# Service Bulletin

**SUBJECT:** Service Update for Inventory and Customer Vehicles  
TCM Harness Routing  
Expires with Base Warranty

**MODELS:** 2015 Chevrolet Silverado  
2015 GMC Sierra  
HD Vehicles Equipped with Dual Generators (KHB)

Subject: 15217 – Service Update Bulletin  
TCM Harness Routing

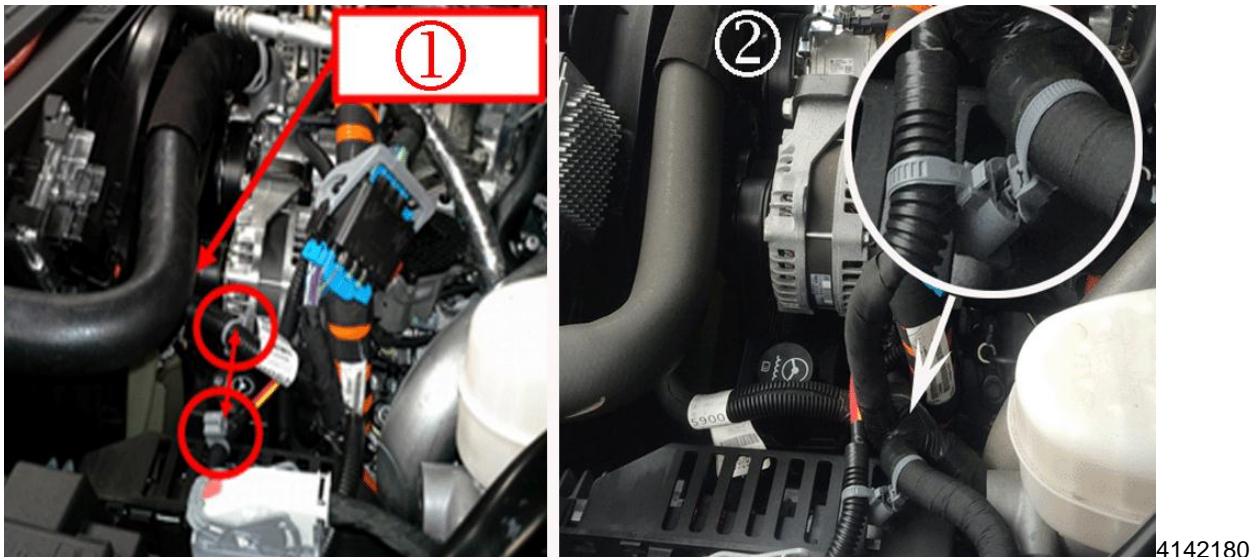
**Note:** Item (1) shows the generator contact area of the TCM harness along with the disconnected two part clip. Item (2) shows the correctly fastened clip, retaining the TCM harness away from the generator.

2. Inspect the area to the left of the generator. Look for the gray two piece fir tree and buddy clip fastening the TCM harness to the auxiliary positive battery cable.
  - If the clip is fastened, no further action is needed.
  - If the clip is present but the two parts are not fastened, join the two parts of the clip.
  - If the clip is missing, or unable to be fastened, install a new fir tree fastener with tie straps on the harness to connect to the buddy clip.
  - If the TCM harness conduit is worn through at the serpentine belt, tape and secure the conduit in the affected area.
